## Board of Architectural Review

DATE: November 7, 2018  
TO: Board of Architectural Review Chair and Members  
THROUGH: Jason Sutphin, Community Development Division Chief *(JS)*  
FROM: Tommy Scibilia, BAR Liaison *(TS)*  
SUBJECT: Capstone

1. Case Number:	BAR-18-00720
2. Address:	3807 University Drive, 10366, 10368, 10370, 10372, 10374, 10378, 10380, 10382, 10386, 10388, 10390, 10392, 10394, 10396, 10398 Democracy Lane
3. Request:	Multifamily development
4. Applicant:	Capstone Collegiate Communities, LLC
5. Applicant's Representative:	Robert Brant
6. Status of Representative:	Agent
7. Current Zoning:	CR Commercial Retail
8. Proposed Zoning:	PD-R Planned Development Residential, Old Town Fairfax Transition Overlay District

⑤ CENTRAL BREEZEWAY

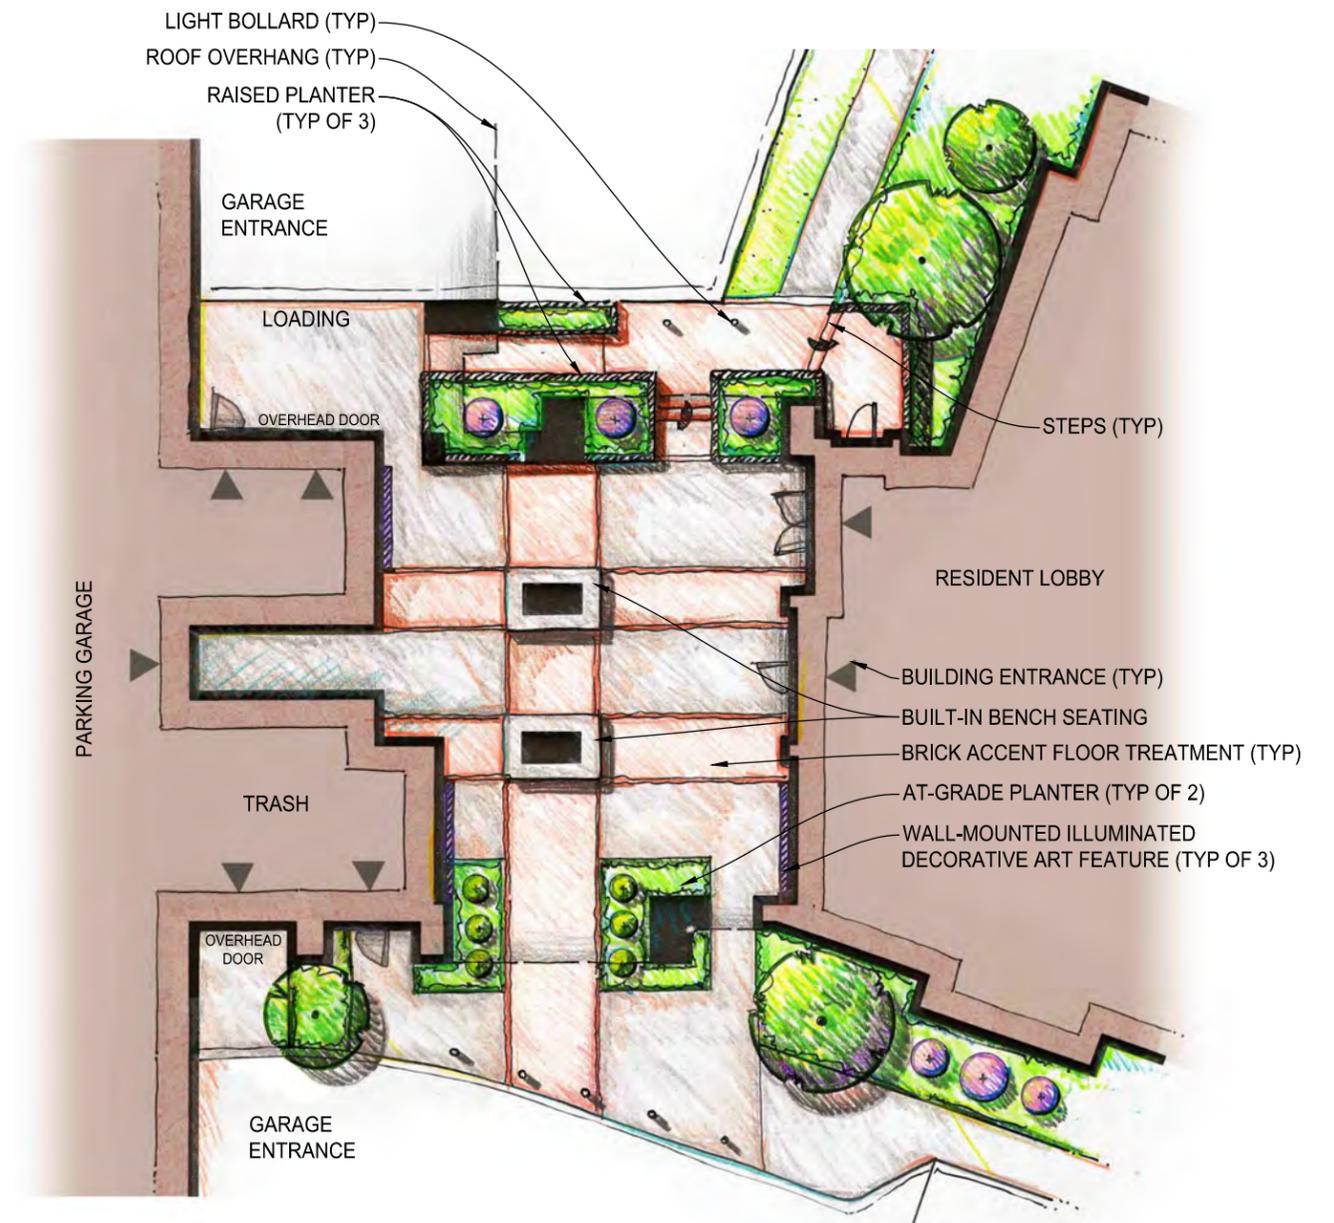
- Safety concern about the number of steps along University Drive for the anticipated young adult residents.
- The bridging of the two halves of the building with a plaza (central breezeway) is a good design element.

# University Dr Elevation - Compartment "C"

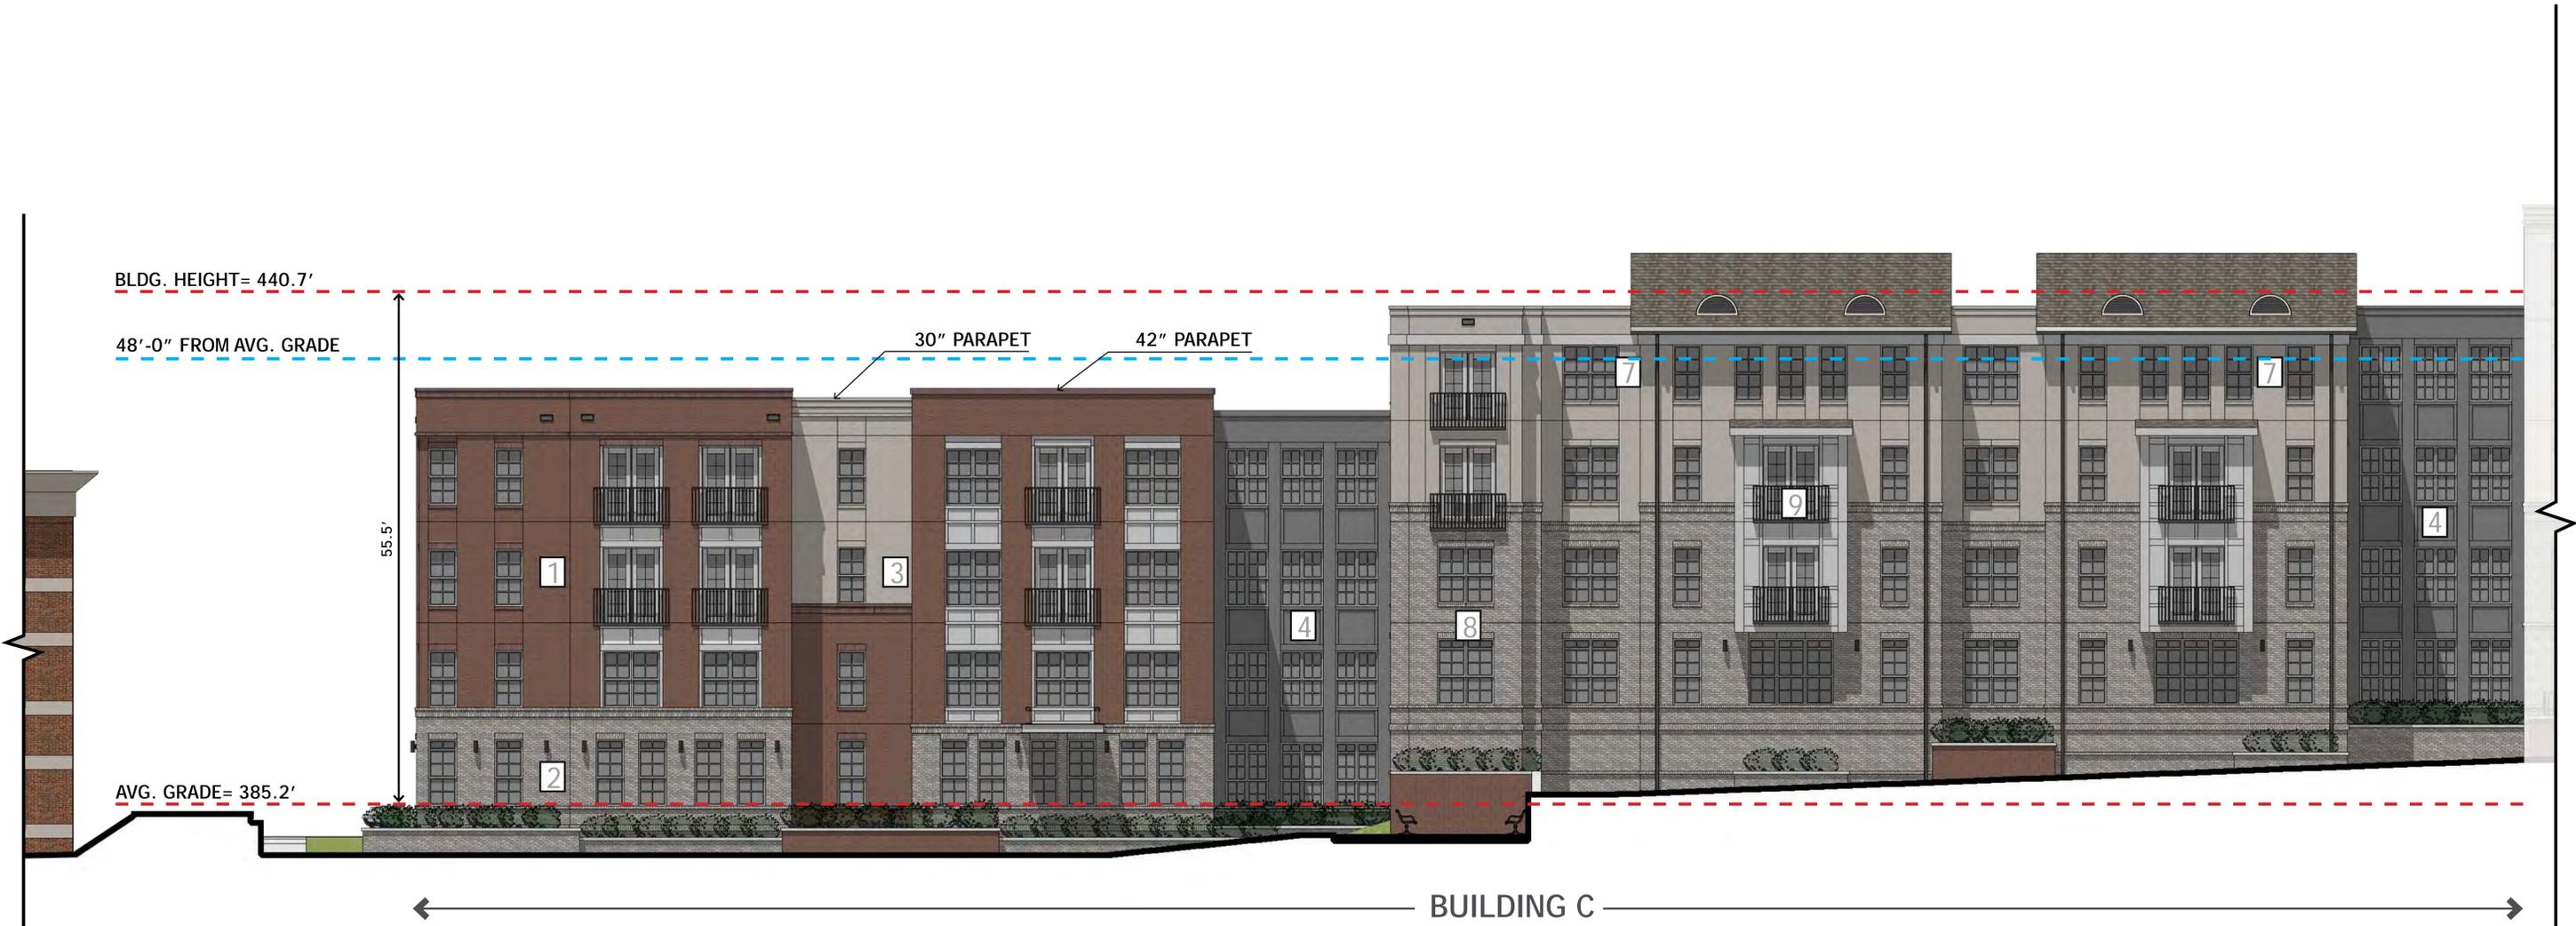
- A method of adding articulation could be introducing more brick colors to create a less repetitive material rhythm along University Drive.
- Look at Old Town Plaza, south on University from the site, as a design precedent. During the design review process, the building was broken up visually by creating two deep cuts in the building wall to make one large building appear to be three buildings.

- This project would be a good precedent for redevelopment in this part of the City.
- Concern about privacy for first floor residents on the University Drive side of the building, with the inner sidewalk and seating areas proposed so close to the building face. Is the inner sidewalk necessary?

Mohsen in response to Cunningham: The jogs in the University Drive elevation as proposed are approximately four to five feet in depth. The applicant will explore bringing portions of the building face out further, closer to the street, to add articulation. Another method of adding articulation could be introducing more brick colors to create a less repetitive material rhythm along University Drive.

Mohsen in response to Cox (above): The raised planters were intended to be used as a means of screening ground floor units. The applicant is open to exploring locating gathering areas along University Drive off of the outer sidewalk rather than the inner sidewalk, and having sidewalk connections to the entrances for this façade and the side entrance connect directly to the outer sidewalk.

# Layton Hall Dr Elevation - Compartment "C"

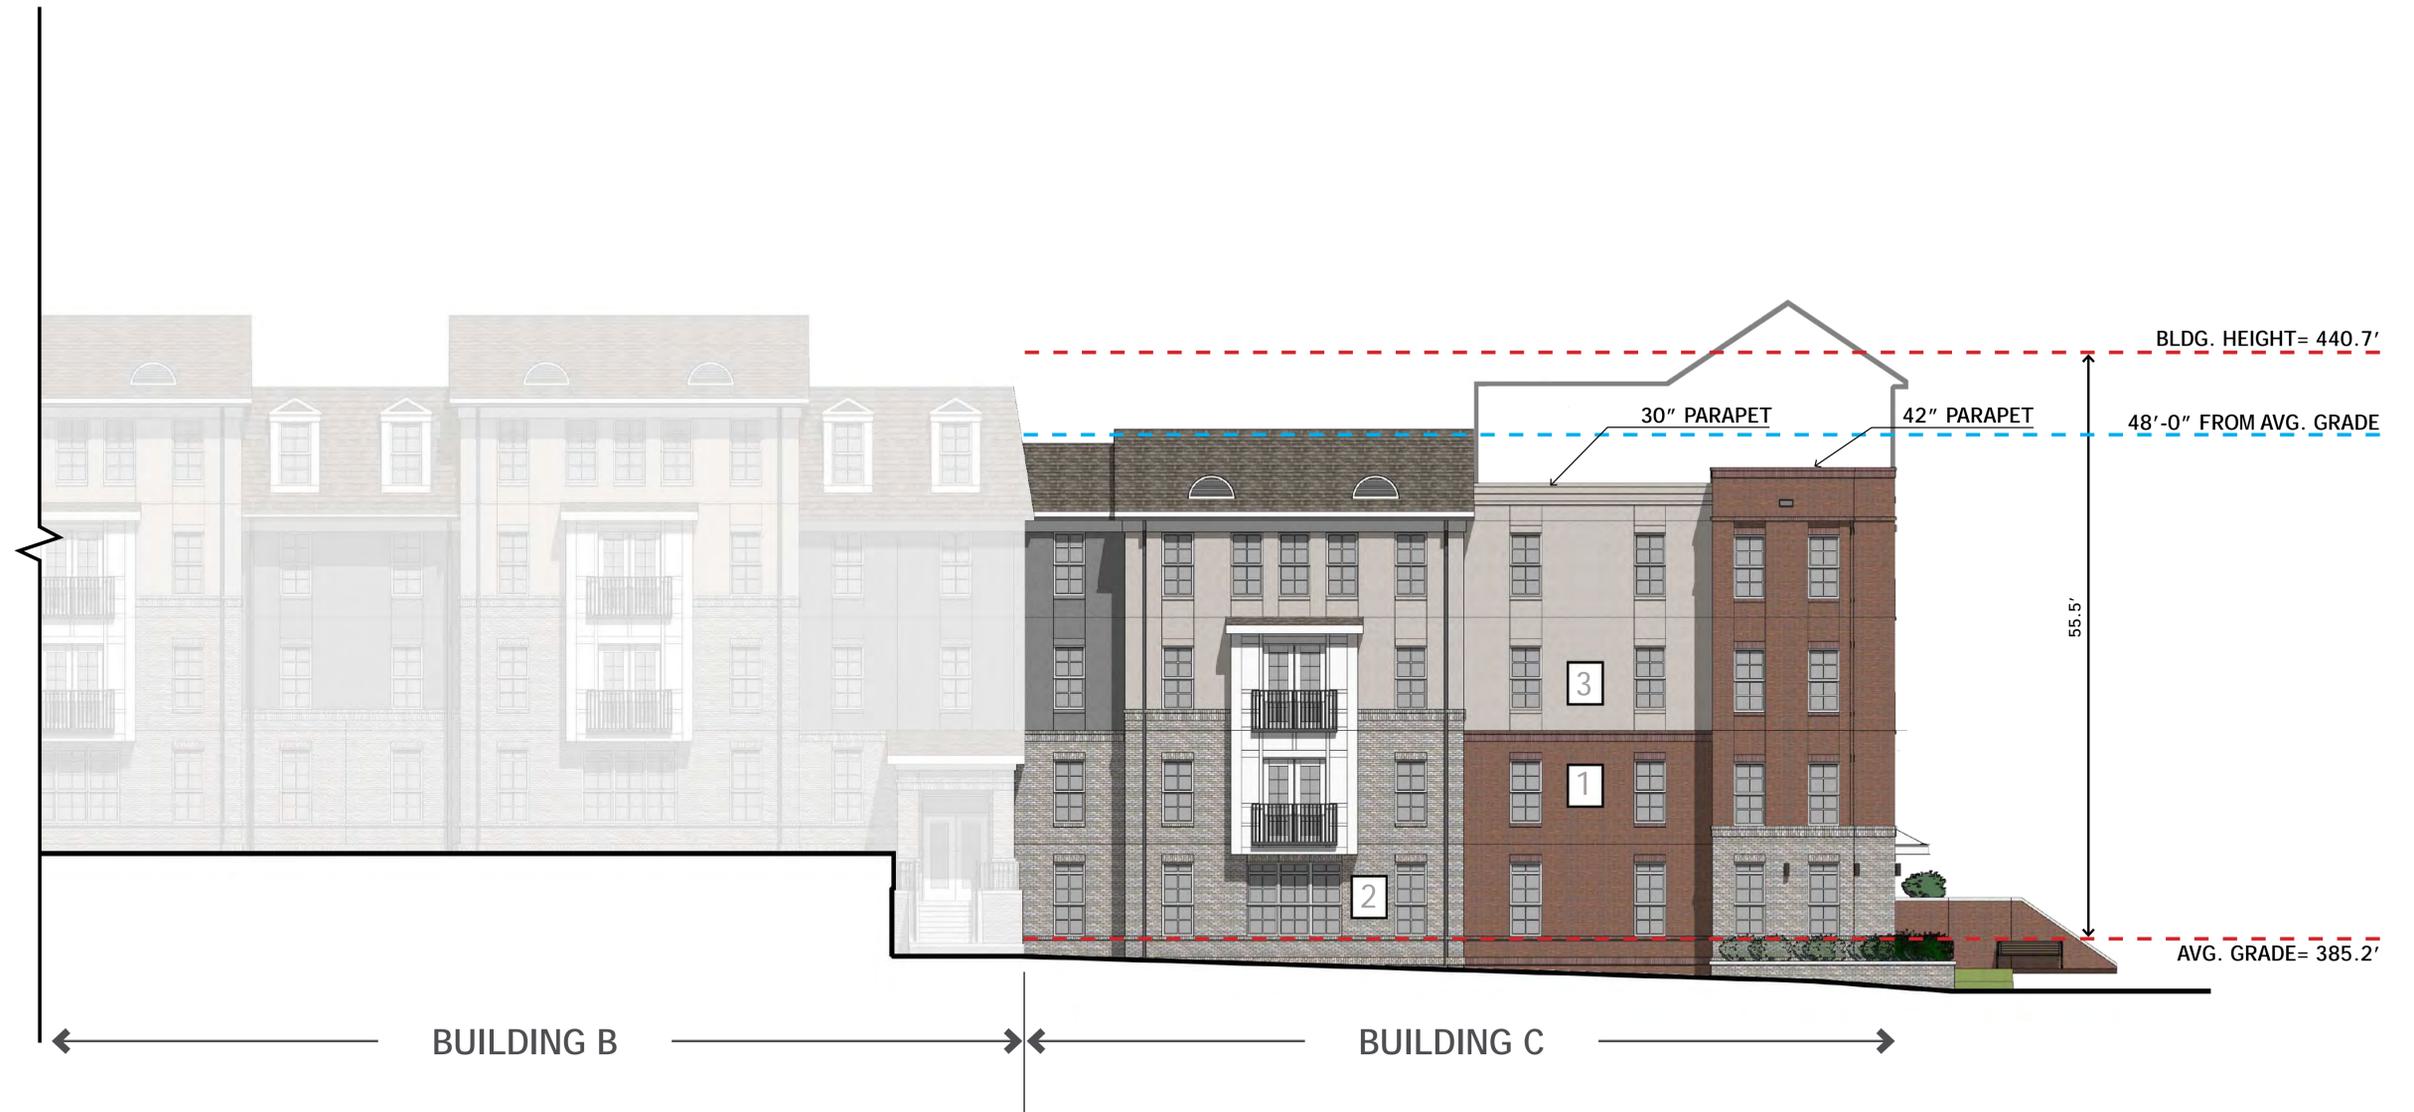
- The elevations visible from Layton Hall Drive need to employ more masonry into their design.
- The height of the building would not be an issue if properly screened. See example at 10201 Fairfax Boulevard, a five story office building at the top of a hill that is well screened with mature landscaping.

- The elevation of the building along Layton Hall Drive at the top of the medical office building property retaining wall is very tall. Consider redistributing the units on the fifth floor to elsewhere in the development (see further explanation in the Proposal section of the report).
